WATER QUALITY MEMORANDUM

Utah Coal Regulatory Program

RE: 2010 Second Quarter Water Monitoring, Canyon Fuel Company, LLC, SUFCO Mine, C/041/0002, WQ10-02, Task ID #3572

Mine Water Discharge and Total Dissolved Solids Concentrations

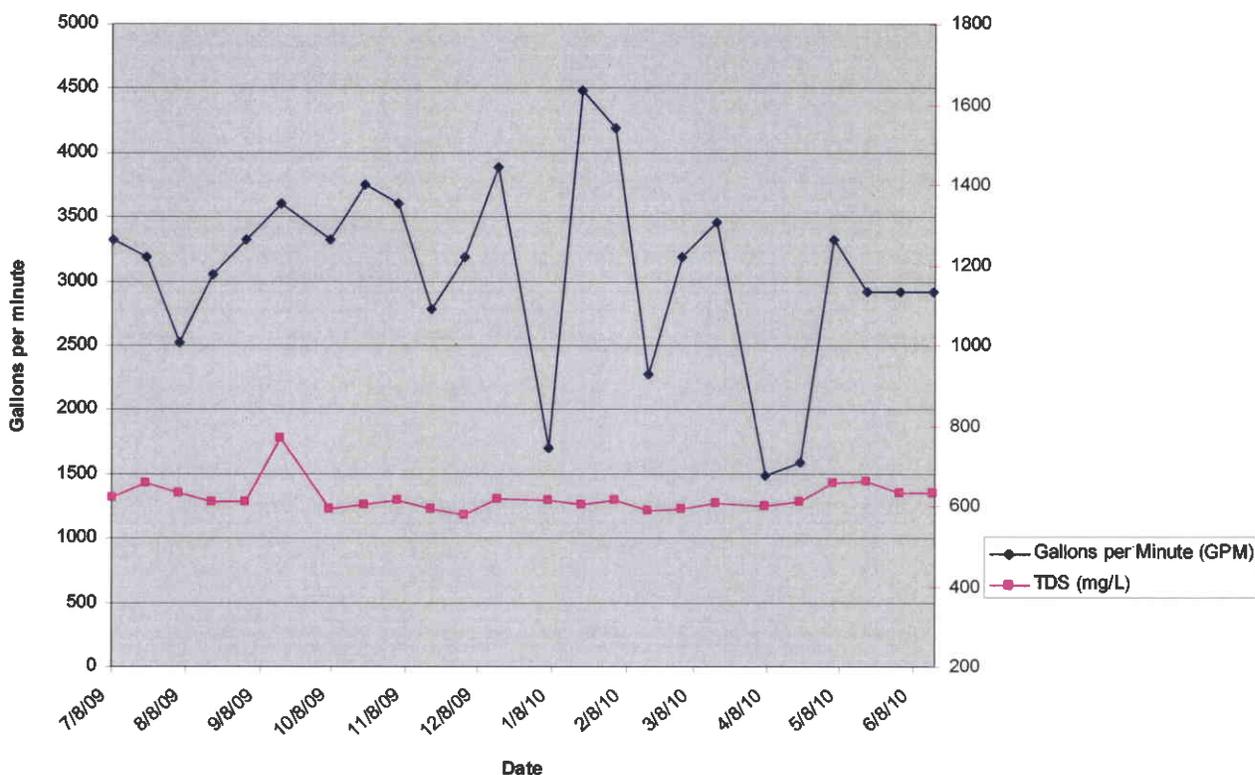
The Permittee submitted all required samples for the UPDES sites. Outfall 001 reported no flow this quarter. The mine water discharge outfall location to the North Fork of Quitchupah Creek averaged a flow of 2,522 gallons per minute (gpm) and an average Total Dissolved Solids (TDS) concentration of 667 mg/L this quarter. The chart below presents a more historical representation of mine water discharge and its relationship to TDS concentrations in the mine water.
